Well Name: STEEL GUITAR 35-26 FED COM	Well Location: T26S / R29E / SEC 26 / NENE / 32.0184939 / -103.9493558	County or Parish/State: EDDY / NM
Well Number: 410H	Type of Well: OIL WELL	Allottee or Tribe Name:
Lease Number: NMNM19609	Unit or CA Name:	Unit or CA Number:
US Well Number: 3001555940	Operator: WPX ENERGY PERMIAN LLC

Sundry ID: 2832814

Type of Submission: Notice of Intent	Type of Action: APD Change
Date Sundry Submitted: 01/20/2025	Time Sundry Submitted: 01:16
Date proposed operation will begin: 01/20/2025

Procedure Description: Devon Energy Production Co., L.P. (Devon) respectfully requests a drilling plan change for the subject well. This includes a change to the intermediate casing set depth from 10189 to 9653. Devon also requests break test and offline cementing variances. Updated drill plan and variance attachments included.

Section 2 - Blowout Preventer Testing Procedure

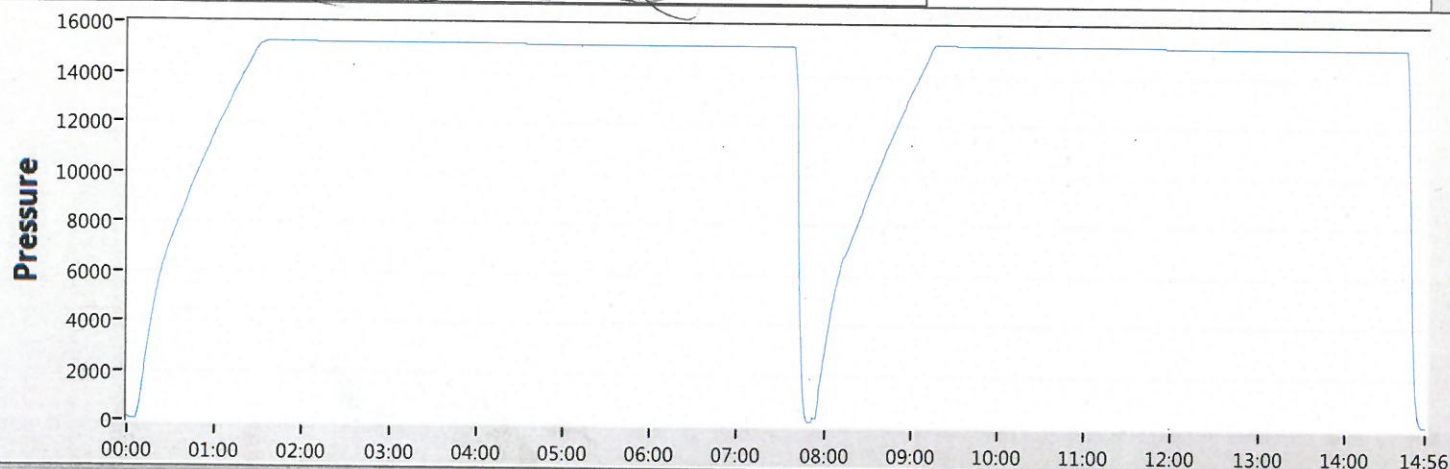
Devon Energy requests to only test BOP connection breaks after drilling out of surface casing and while skidding between wells which conforms to API Standard 53 and industry standards. This test will include the Top Pipe Rams, HCR, Kill Line Check Valve, QDC (quick disconnect to wellhead) and Shell of the 10M BOPE to 5M for 10 minutes. If a break to the flex hose that runs to the choke manifold is required due to repositioning from a skid, the HCR will remain open during the shell test to include that additional break. The variance only pertains to intermediate hole-sections and no deeper than the Bone Springs Formation where 5M BOP tests are required. The initial BOP test will follow 43 CFR 3172, and subsequent tests following a skid will only test connections that are broken. The annular preventer will be tested to 100% working pressure. This variance will meet or exceed 43 CFR 3172 per the following: Devon Energy will perform a full BOP test per 43 CFR 3172 before drilling out of the intermediate casing string(s) and starting the production hole, before starting any hole section that requires a 10M test, before the expiration of the allotted 14-days for 5M intermediate batch drilling or when the drilling rig is fully mobilized to a new well pad, whichever is sooner. We will utilize a 200' TVD tolerance between intermediate shoes as the cutoff for a full BOP test. The BLM will be contacted 4hrs prior to a BOPE test. The BLM will be notified if and when a well control event is encountered. Break test will be a 14 day interval and not a 30 day full BOPE test interval. If in the event break testing is not utilized, then a full BOPE test would be conducted.

1. Well Control Response:
 1. Primary barrier remains fluid
 2. In the event of an influx due to being underbalanced and after a realized gain or flow, the order of closing BOPE is as follows:
 - a) Annular first
 - b) If annular were to not hold, Upper pipe rams second (which were tested on the skid BOP test)
 - c) If the Upper Pipe Rams were to not hold, Lower Pipe Rams would be third

BOPE Break Testing Variance

- **BOPE Break Testing is ONLY permitted for 5M BOPE or less. (Annular preventer must be tested to a minimum of 70% of BOPE working pressure and shall be higher than the MASP)**

- **BOPE Break Testing is NOT permitted to drilling the production hole section.**
- **Variance only pertains to the intermediate hole-sections and no deeper than the Bone Springs formation.**

- **While in transfer between wells, the BOPE shall be secured by the hydraulic carrier or cradle.**
- **Any well control event while drilling require notification to the BLM Petroleum Engineer (575-706-2779) prior to the commencement of any BOPE Break Testing operations.**

- **A full BOPE test is required prior to drilling the first deep intermediate hole section. If any subsequent hole interval is deeper than the first, a full BOPE test will be required. (200' TVD tolerance between intermediate shoes is allowable).**

- **The BLM is to be contacted (575-361-2822 Eddy County) 4 hours prior to BOPE tests.**
- **As a minimum, a full BOPE test shall be performed at 21-day intervals.**

- **In the event any repairs or replacement of the BOPE is required, the BOPE shall test as per 43 CFR part 3170 Subpart 3172.**
- **If in the event break testing is not utilized, then a full BOPE test would be conducted.**
